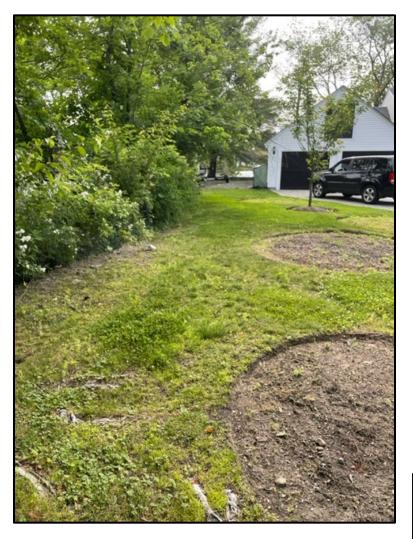
Photo 2: Area of wall required to be removed to save tree. Recommend additional buffer zone plantings in this area (6.17.22).
